# BENSALEM TOWNSHIP

Appeal Number: 2016-483

### Township of Bensalem, Bucks County, Pennsylvania Notice of Appeal

<b>Project:</b>	<b>INGROUND POOL</b>
<b>Project Address:</b>	<b>1685 POINT DR BENSALEM, PA 19020</b>
<b>Tax Parcel:</b>	<b>02-052-2221</b>
<b>Property Owner:</b>	<b>SAME AS ADDRESSED</b>
<b>Permit Status:</b>	<b>APPLICATION DENIED</b>

FILE NO: B23207 DATE: 1/8/2016 SCALE: 1" = 20 FEET SHEET NO: 1 OF 1

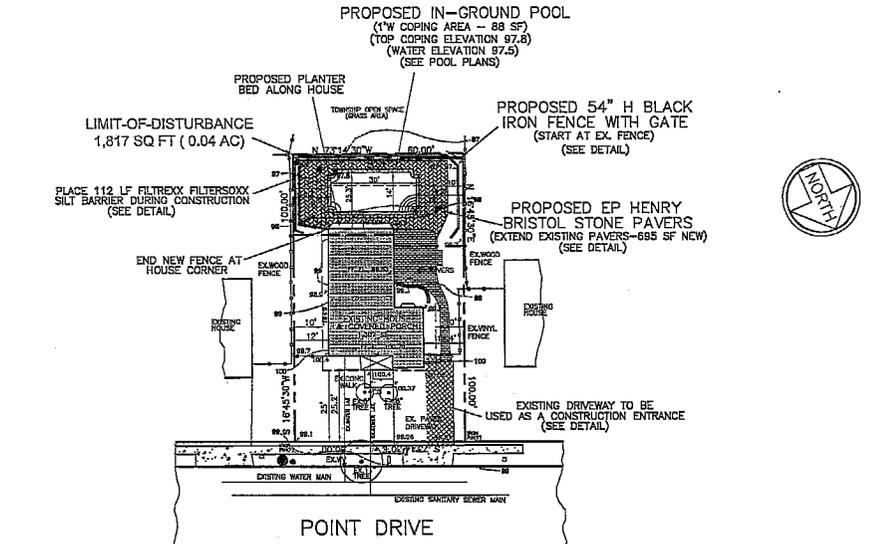
The proposed impervious surface coverage of 51.3% exceeds the allowable 45% [ Section 232-167(d)(1)]

REvised 02/23/18 AS PER TWP REVIEW
